CITY OF ALBUQUERQUE

**RE: Del Webb @ Mirehaven Phase 2A
Grading & Drainage Plan Revision 4
Engineer's Stamp Date 3-11-16 (Rev. 4 Date: 08/17)
Hydrology File: H09D017F**

Re: Revised Grading and Drainage Plan, Del Webb @ Mirehaven, Phase 2A
DRB Case No. 1006864

DESIGN REVIEW COMMITTEE	CITY ENGINEER APPROVAL	LAST DESIGN UPDATE	MO./DAY/YR.	MO./DAY/YR.
PROJECT NO.		ZONE MAP NO.	SHEET 3 OF 7

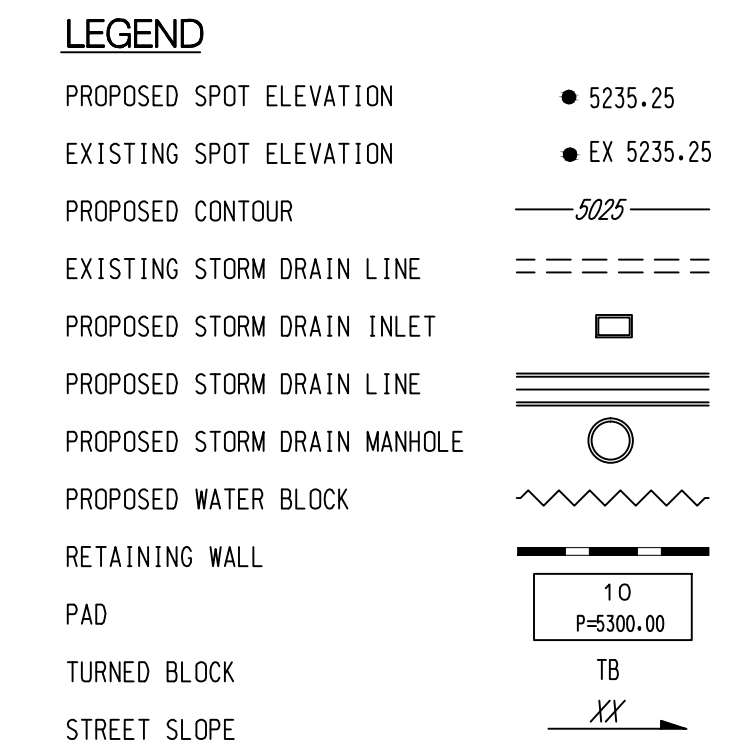
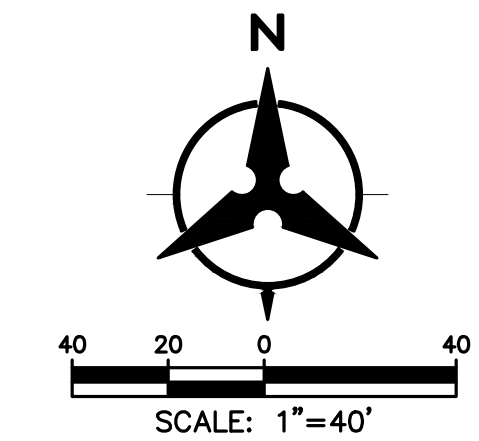
1. An Engineer Certified Addendum to the Drainage Report is required to support the new drainage pattern. The following should be addressed:
 - a. Proposed Basin Map: Basin G.5 will now drain into G.6
 - b. Geometry and hydraulic capacity of the new swale adjacent to lot 22.
 - c. Hydraulic capacity of the swale behind lots 16-22, accounting for the additional flow from G.5. This swale may need to be upsized.

TYPICAL CROSS SECTION E-E
NOT TO SCALE

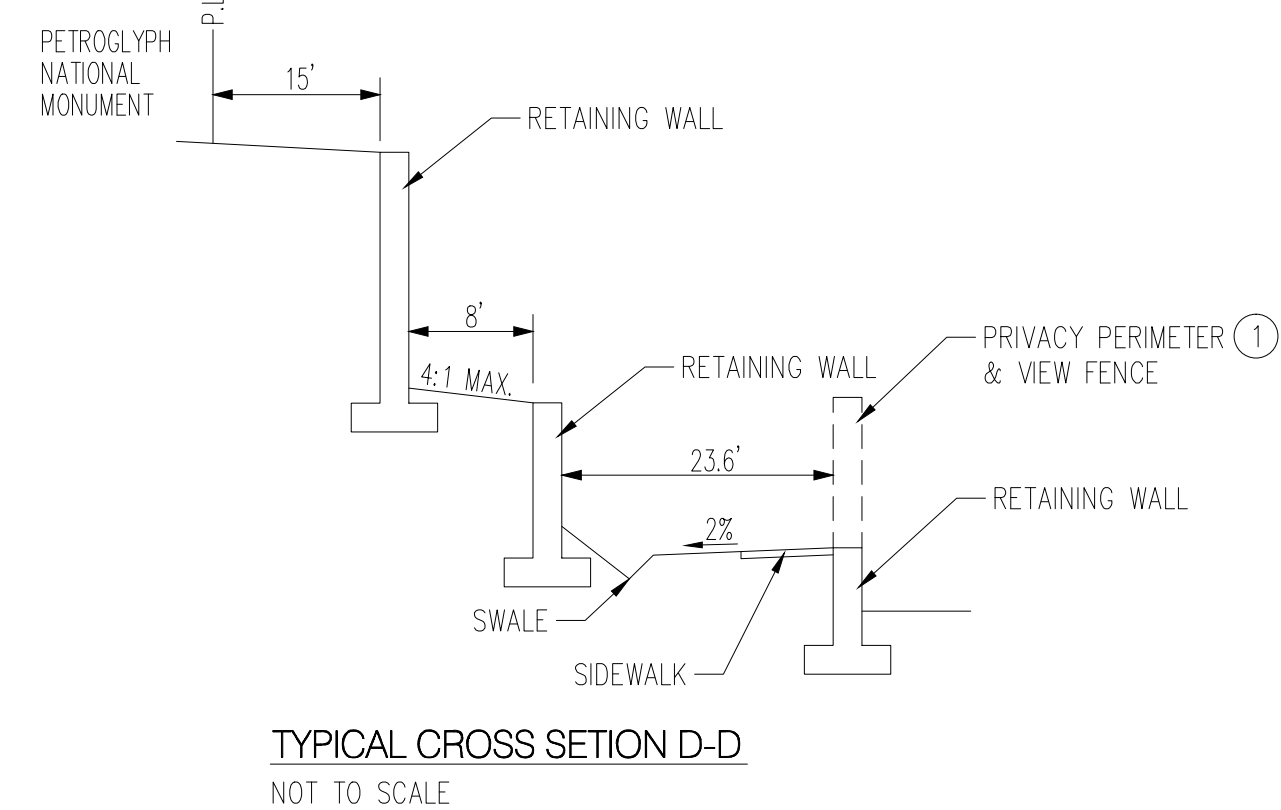
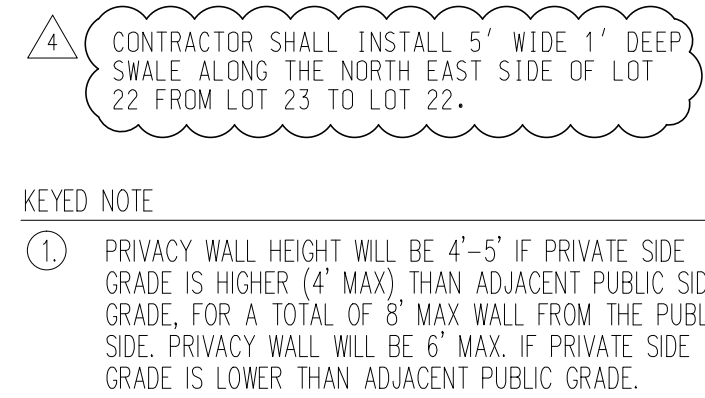
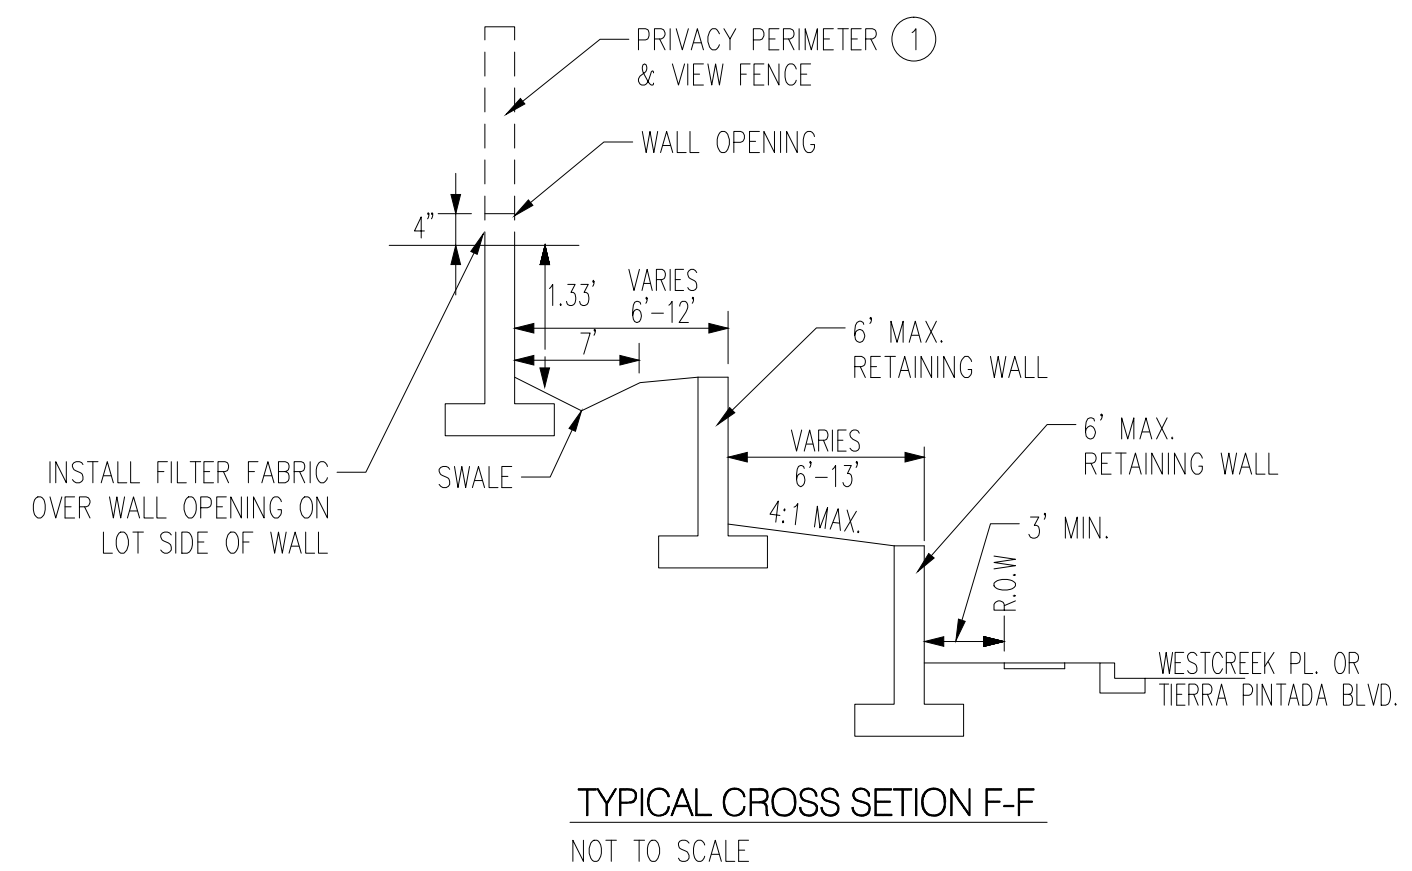
The revision consists of adding a swale along the eastside of Lot 22 to convey the flow from lots 23-27 to the swale behind lots 16-22 and down to the pond located at the southern corner of the development as should on Sheet 7 of 7.
